In accordance with our mandate under Article II, Section 1 of Council Policy 600-24 to make recommendations to the City Council, Planning Commission, and City staff concerning the preparation of, adoption of, implementation of or amendment to a land use plan, the Serra Mesa Planning Group hereby presents the following comments for inclusion in the staff report to the Planning Commission and City Council on the Proposed Serra Mesa Community Plan Amendment Roadway Connection Project, Project No. 265605 SCH No. 2012011048.

**SERRA MESA PLANNING GROUP’S SUMMARY/POSITION STATEMENT**

## Analysis of the LOS Level Long-Term Baseline vs Long-Term Cumulative with Project\*

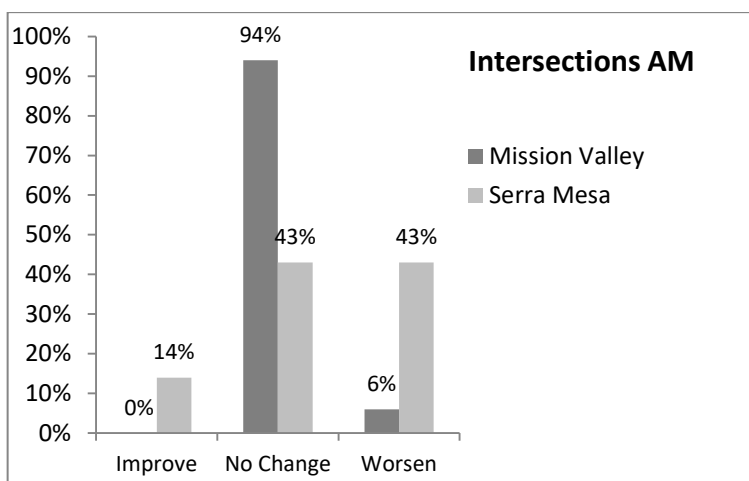
In both Serra Mesa and Mission Valley the greatest percentage of the roadway segments will receive the same LOS level. Also, in Serra Mesa  $\frac{1}{3}$  of the segments will worsen and none will improve.

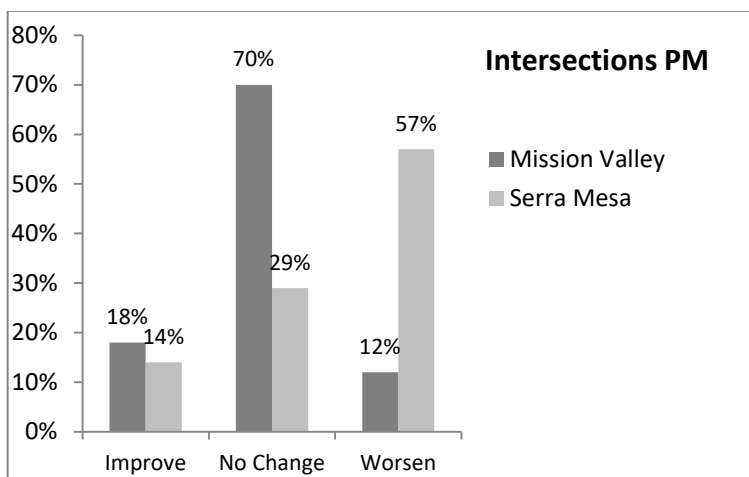
The LOS No Change is almost 100% percentage for Mission Valley while in Serra Mesa both No Change and Worsen receive the same percentage.

In Mission Valley 70% of the intersections won't change LOS level while in Serra Mesa more than half of the intersections will worsen.
